Docket #8
CD-CPC-2026-00023
Development Plan – M1-5

5019 Raytown Road

April 15, 2026

City Planning Commission

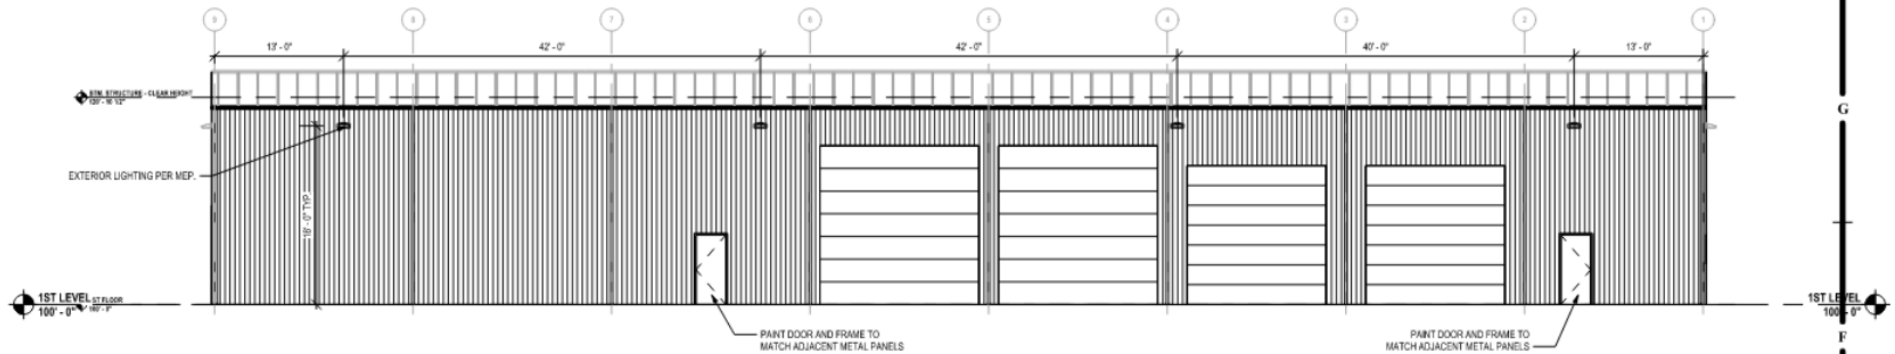
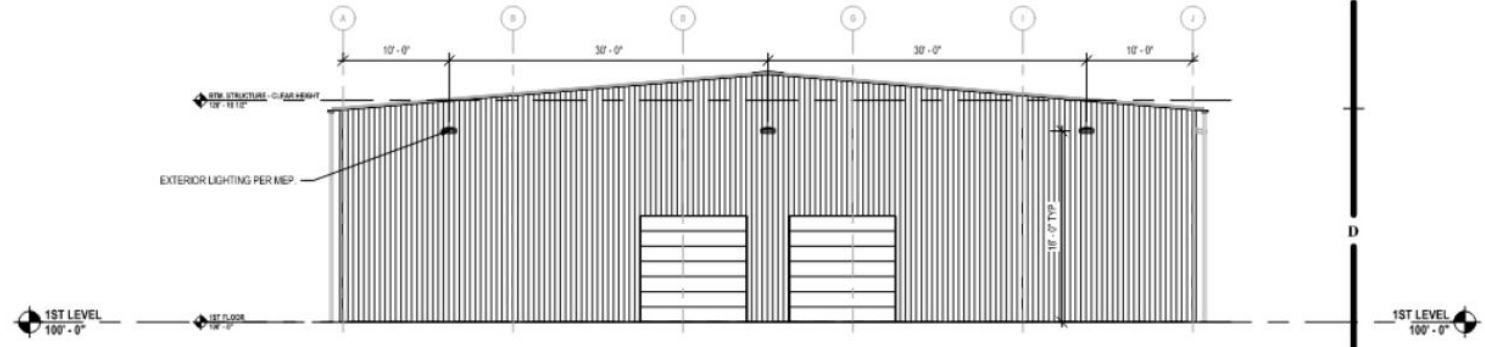
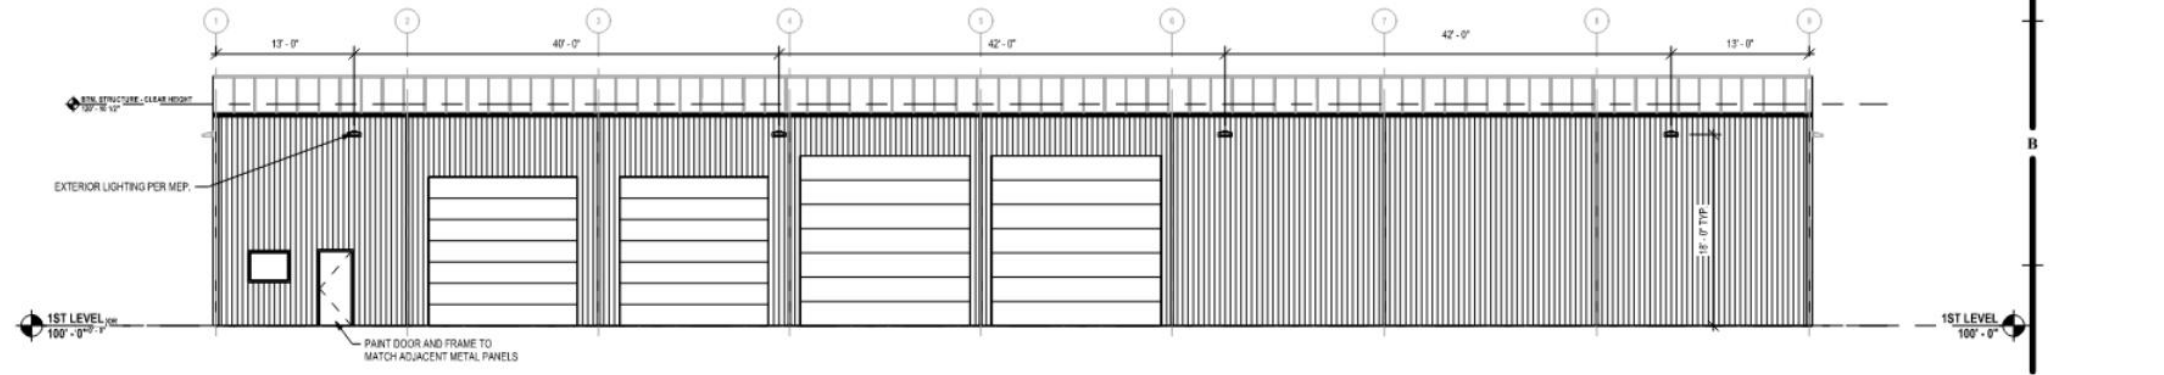
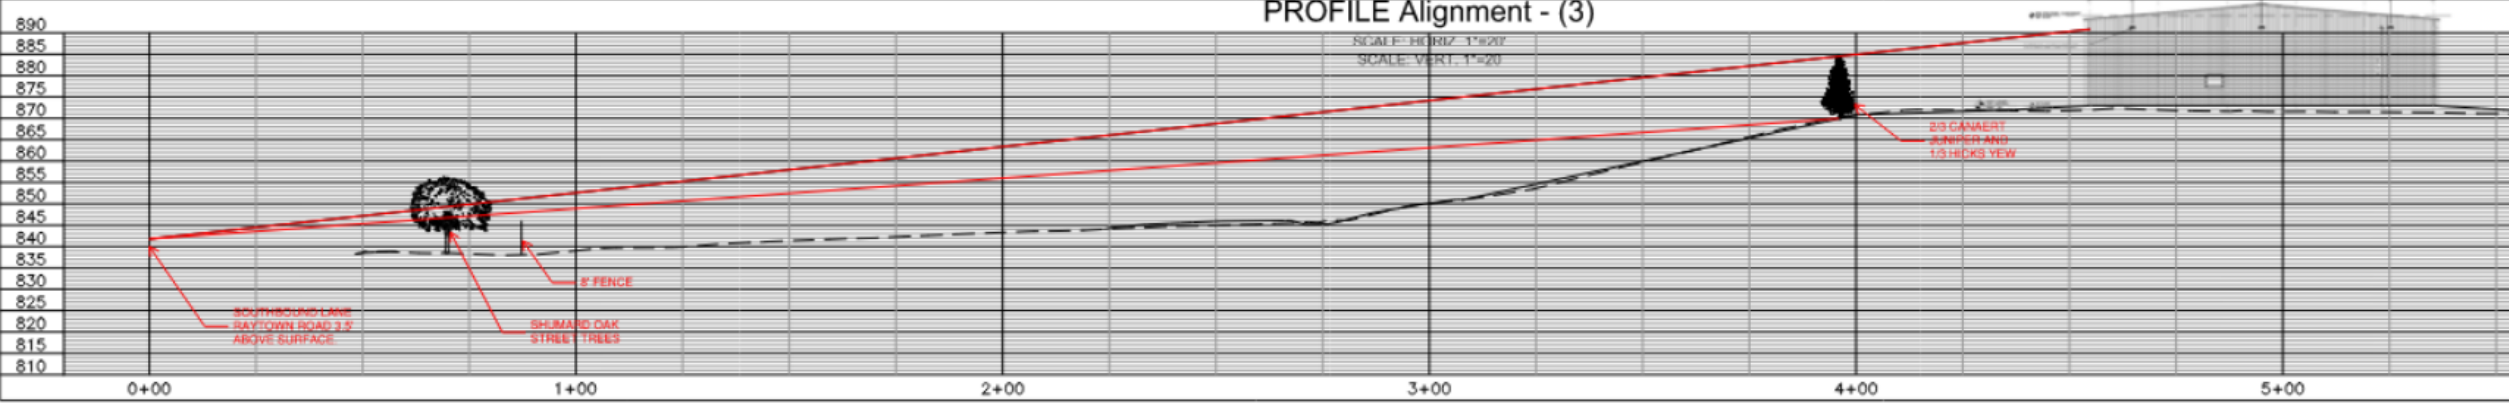
- 15. The applicant shall revise the building elevations to apply high quality building materials including but not limited to brick, stone, cast stone, finished concrete, stucco (not EIFS), metal (not sheet or pan style), or cement board to the front facade of the proposed building facing Raytown Road to increase alignment with design guidelines in the area plan and KC Spirit Playbook and Raytown Road's identified Image Street status. This shall be completed prior to ordinance request.

- 16. The applicant shall revise elevations to add eye-level windows with two-way transparency, clerestory windows, or material changes to the front facade of the proposed building facing Raytown Road to better align with the Well-Designed City goal of the KC Spirit Playbook. Denote on the elevations the material type and location on the elevation drawings. This shall be completed prior to ordinance request.
